TOWN OF WESTPORT ARCHITECTURAL REVIEW BOARD

TUESDAY, APRIL 23, 2024 - MINUTES

3. **280 Compo Road South:** Proposed renovations to the inn, restaurant and event space at 260 Compo Road South (Parcel ID# C04/001/000) submitted by Peter Romano, LANDTECH, for property owned by the Town of Westport which is located in Zone AAA-AA) (Site plan: LANDTECH dated 3/5/24; Building design Ken Nadler Architects, dated 4/9/24)

R E A R (S O U T H) E L E V A T I O N

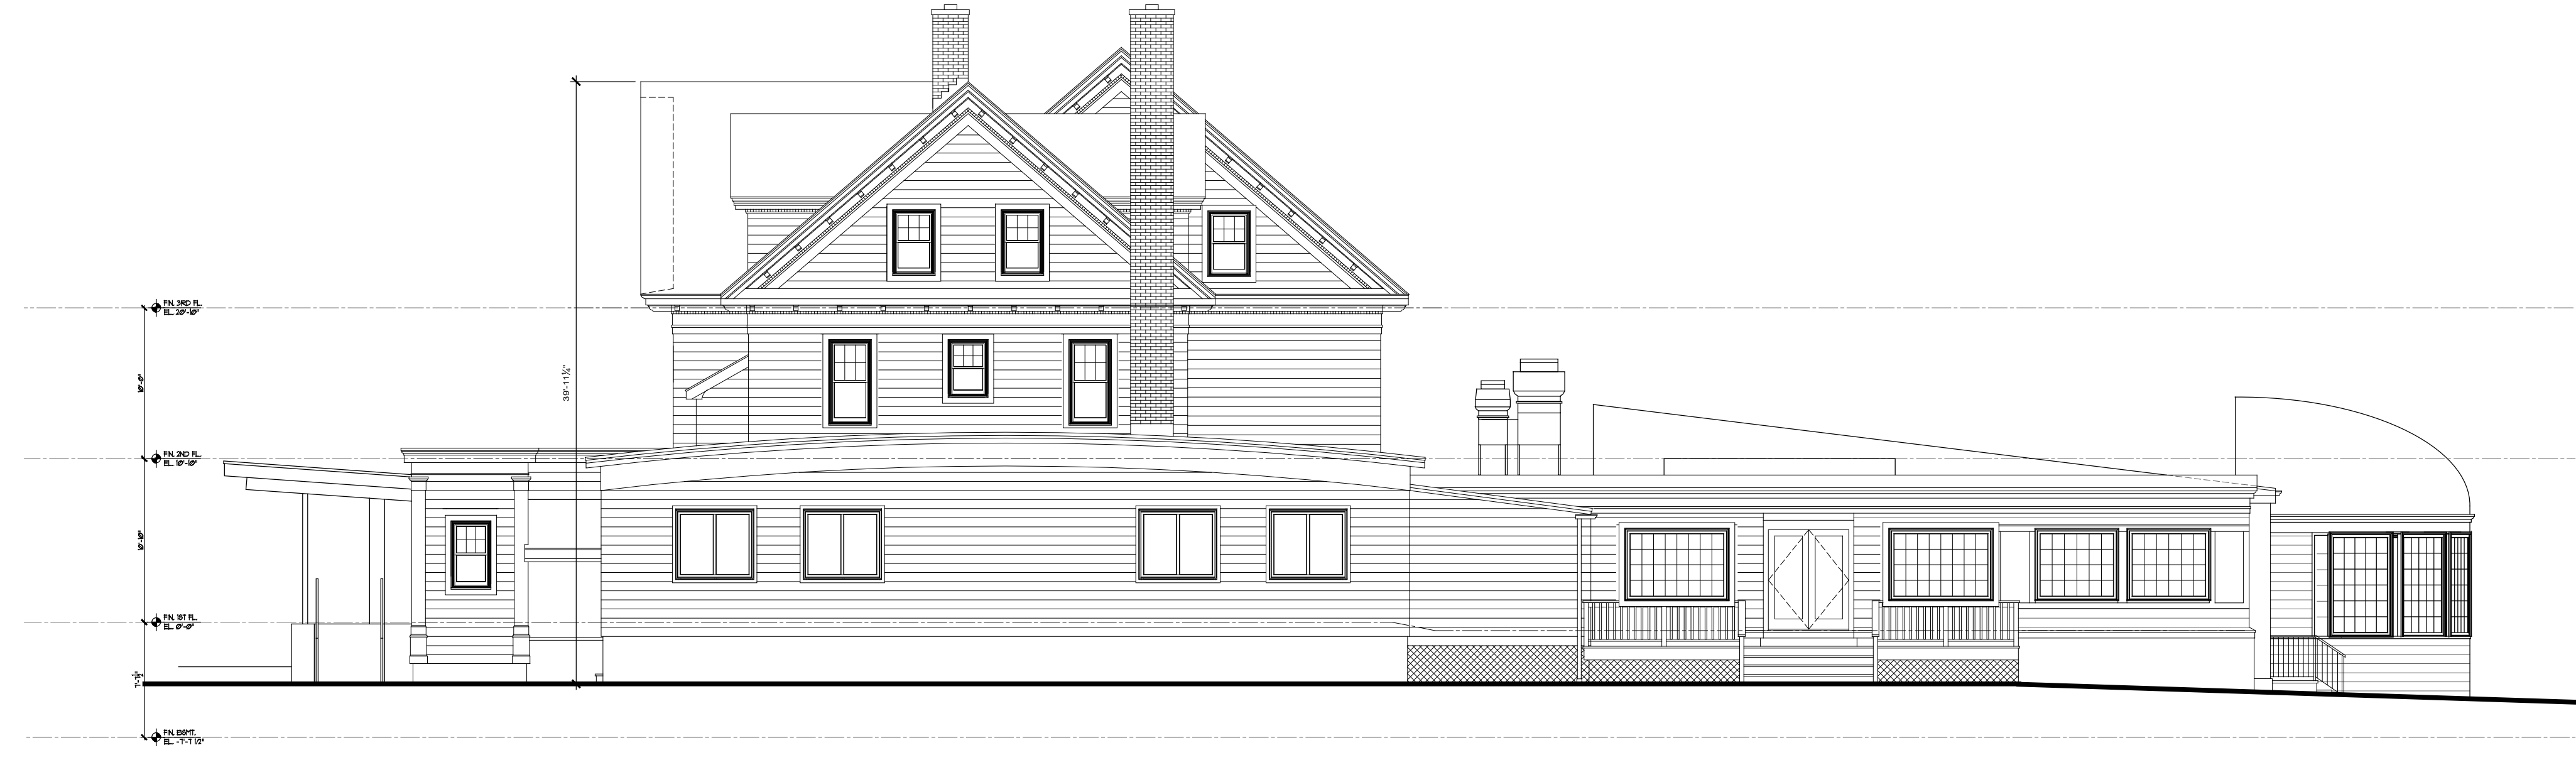
Vesna Herman agreed with Mr. Halpern about the scale of the port cochere, it is too big and needs to be scaled down. She agreed that the floor plans have been done really well, especially the entrance with the site line to the water. She said the architectural elements at the rear of the building look dry and institutional, the columns are too uniform.

Ward French said the lack of presence of the rear elevation concerned him, the appendages added to the rear take away from the elevation and make the entire structure disappear. All that flat roof is massive and obfuscates the building behind it. I understand you are making the building more functional but the proportions of the port cochere and the rear need to be reduced.

Jon Halper said he was struggling with what the goal of the project is, what are we turning it into? It's a quirky old building that is having some nice expensive pieces added to it. What is the architectural goal of the project? The disconcertingly large port cochere doesn't align with the front gables and the Juliette balcony is...eh. The rear program is done skillfully, but it's a layer cake of flat roofs and an undistinguished 2nd floor. It's blah from the water.

Ward French said the rear terrace pavilion is massive relative to the existing building.

Vesna Herman said we are all looking for a point of reference on the rear elevation. The massing is so uniform, it needs...Mr. Nadler said it needs a focal point. Board members agreed.

THE APPLICANTS WERE ASKED TO TAKE BOARD MEMBERS COMMENTS INTO CONSIDERATION AND RETURN WITH A REVISED DESIGN. (Unanimous)
